CITY COUNCIL MEETING

9. **SCHEDULED DELEGATIONS**
   - A. West Point Dairy Products, Receiving and Warehouse Expansion – To request site plan approval from the City Council for receiving and warehouse expansion located at 570 North 500 West.

Subject: West Point Dairy Products, Receiving and Warehouse Expansion – Seeking site plan approval from the City Council for receiving and warehouse expansion located at 570 North 500 West.

Fourth Review Application Overview: Hyrum City staff has been working with West Point Dairy Products (WPD) and their consulting engineering firm Excell Engineering through a series of site plan concepts and reviews. At this time, staff is recommending site plan approval as presented in accordance with HCC 17.08.100.C. Upon site plan approval, construction drawings will be required for any public works construction or improvement for approval by the City Engineer.

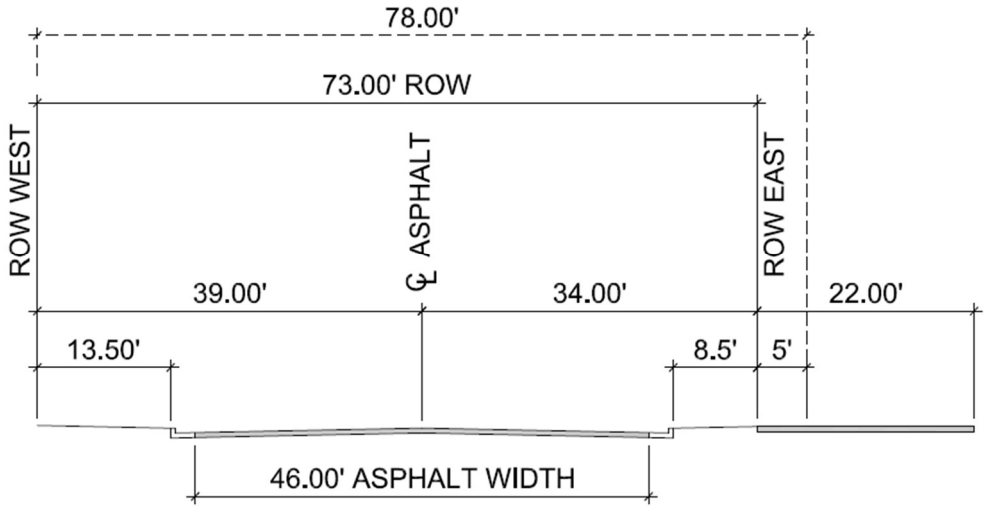
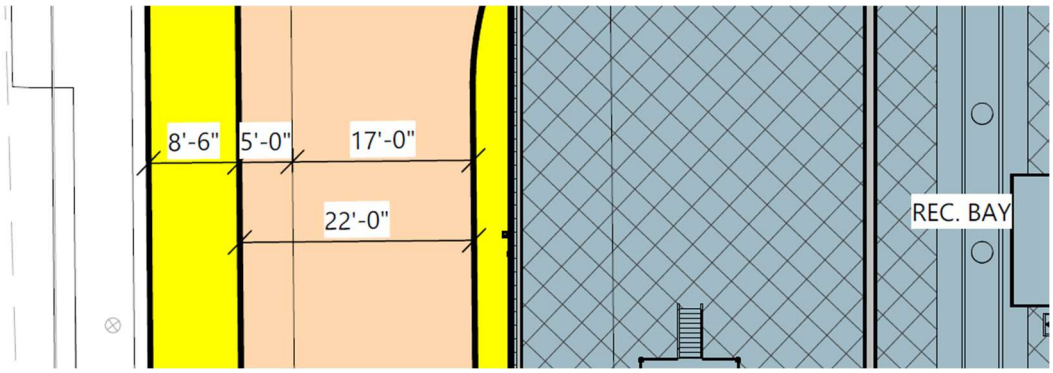
1. In a collaborative effort between Hyrum City and WPD for WPD to comply with HCC 17.49.080, staff is recommending the Planning Commission and City Council approve the following right-of-way width reductions abutting the WPD project:
    a. 500 West right-of-way be reduced from 78.00’ feet to 71.00’ feet; and

b. 700 North right-of-way be reduced from 78 feet to 73 feet.

(13.50’ park strip reduced to 8.5’)

See Sheet T1.1PHA

See Sheet T1.1PHA

SHEET NUMBER
C2.0

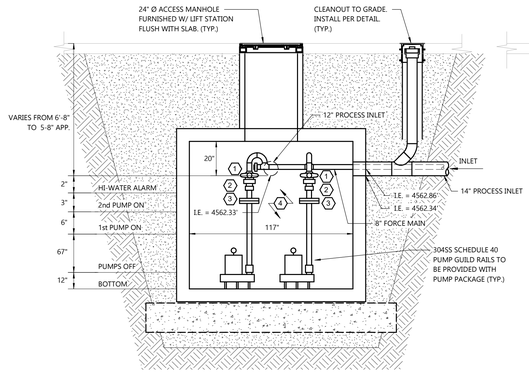
3. Site grading and storm water has also been sent to an engineering firm for storm drain design for 4600 South.
4. On sheet C2.0 please show detail for abandonment of the existing fire line.
5. On sheet C2.0 please show detail for tie in connection for new 8" fire line.
6. Hyrum City recommends looking into a fire pumping system for new and existing buildings with this expansion.

SHEET NUMBER
C3.1

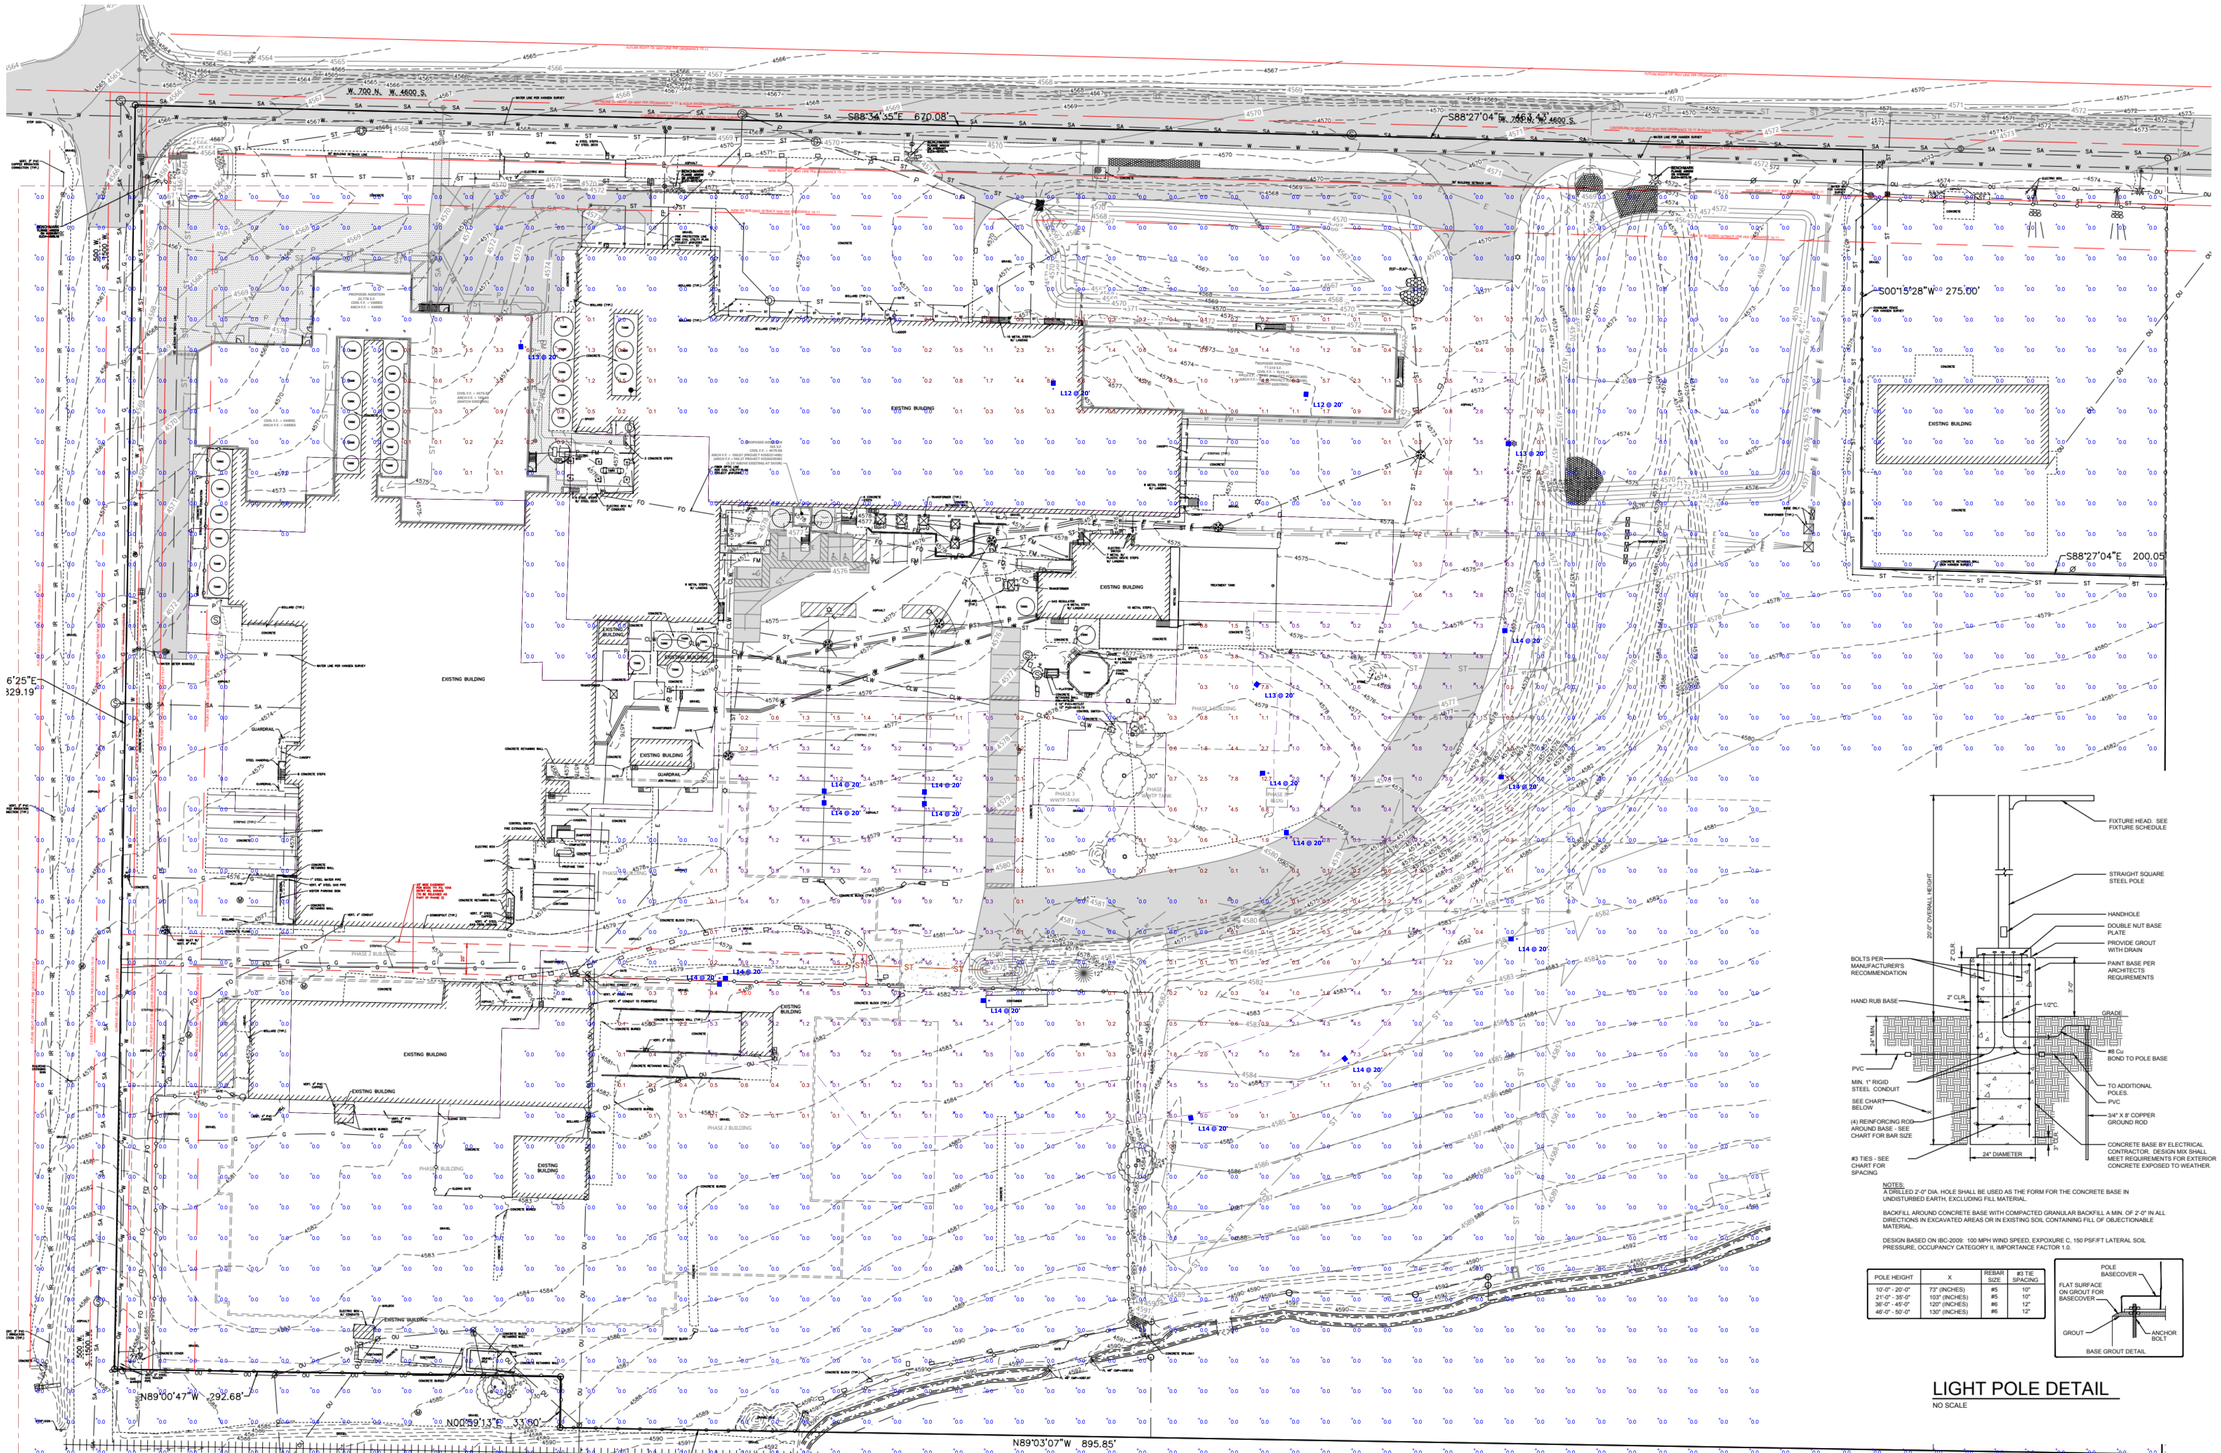
2. HCC 17.49.020 Use Regulations: Food processing/mills is a permitted use in the M-2 Zone.
Excel Response: Understood
3. HCC 17.49.022 Lighting Plan: Sheet C3.1 Civil Site Photometric Plan has been provided for new lighting for the expansion. The lamps in the schedule identify the lamps are to be tilted. Applicant shall verify and comply to this section requiring that all new lighting shall prevent glare onto properties and shall be dark-sky sensitive.
Excel Response: There are no new poles being added as part of this first phase of expansion. Three existing poles are moving slightly to allow for widening of the driveway. The existing poles and light fixtures will be reinstalled at the new locations. Heads will be pointed toward the facility and use cut off fixtures. Maximum light pole height will match existing installation. A light pole detail has been added to Sheet C3.1.

Staff Response: Resolved. The detail provided following the June 16, 2026 discussion is not the detail staff requested. Staff requested specification sheets for each light fixture as Excell provided on Sheet PXP2 of the North Expansion through as separate site plan approval application.
